**Re: Burlington Hydro Inc. (Burlington Hydro)
2026 Cost of Service Rate Application
Ontario Energy Board (OEB) File Number: EB-2025-0051**

OEB Staff Interrogatories
2026 Electricity Distribution Rates Application
Burlington Hydro Inc.
EB-2025-0051
June 30, 2025

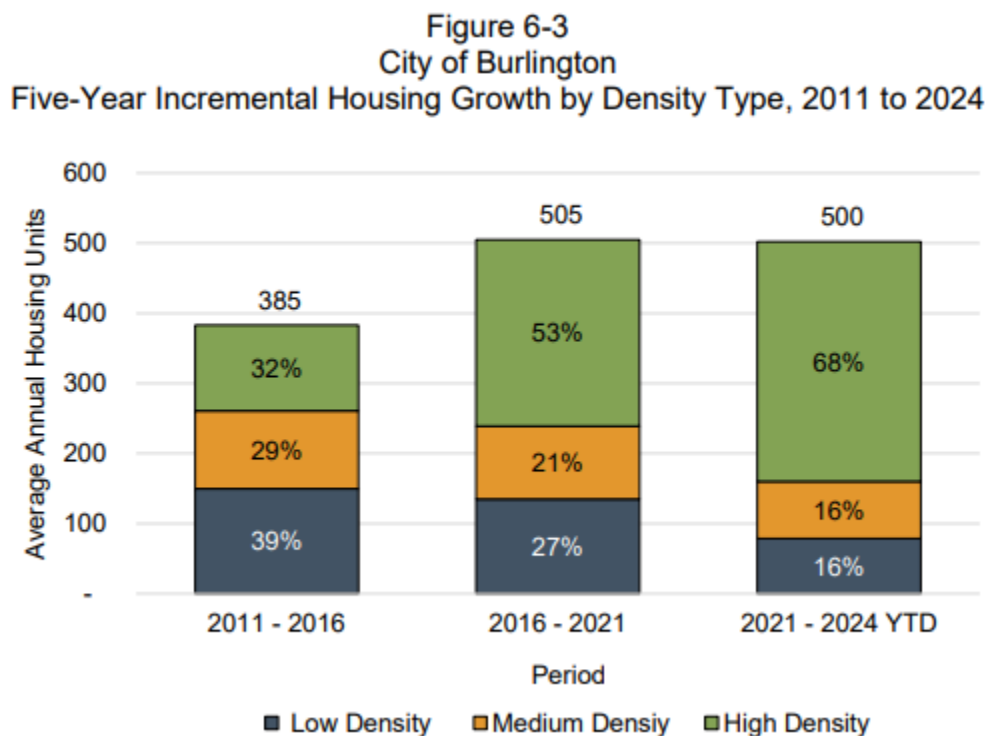
OEB staff notes that Burlington Hydro has made numerous references to both population growth and anticipated construction of 29,000 new housing units by 2031 in the City of Burlington. This assumption is one of the key factors Burlington Hydro identifies as contributing to an expected increase in workload, as well as the justification for the addition of 14 new FTEs in the 2026 Test Year.

In reference 5, Burlington Hydro further states that its forecasted average capital expenditures over the 2026-2030 period are expected to be over 40% higher than the historical average, partly in support of energy transition and growth forecasts.

- Reference 6 above indicates that between 2021-2024, an average of 500 new housing units were constructed annually, a slight decrease from the 2016-2021 average of 505 annually. Given these trends, please provide an explanation for why Burlington Hydro uses the target of 29,000 new housing units as a key reason for the anticipated increase in workload.
- Does Burlington Hydro have any additional information which indicates that the City of Burlington will see a substantial increase in the rate of new home construction in the coming years to meet the 2031 target?
- Does Burlington Hydro believe that this shortfall was due to under resourcing?
